RIDE: Ranger (Kamikaze, Phoenix, Hi Flyer)

SUBJECT: Removable Vehicle Rail

BULLETIN NUMBER: FR027

Drawing B

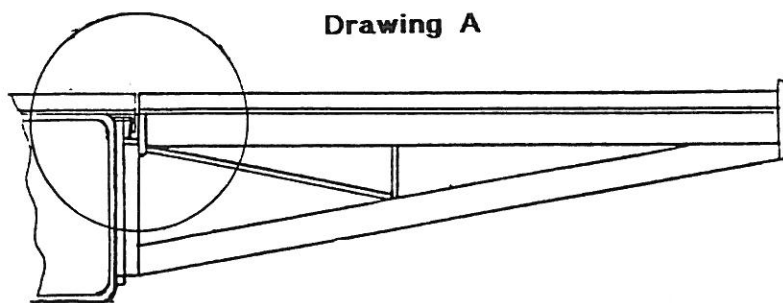
It is recommended by Far Fabbri to inspect the condition of the rail each time the ride is assembled. Pay particular attention to the area indicated in drawing A. To prevent possible fatigue on this structure, avoid loading excess blocking and jack pads in the vehicles.

If signs of stress or cracks are detected, grind area and reweld. If necessary, a support can be placed under the end of the rail, as indicated in drawing B.
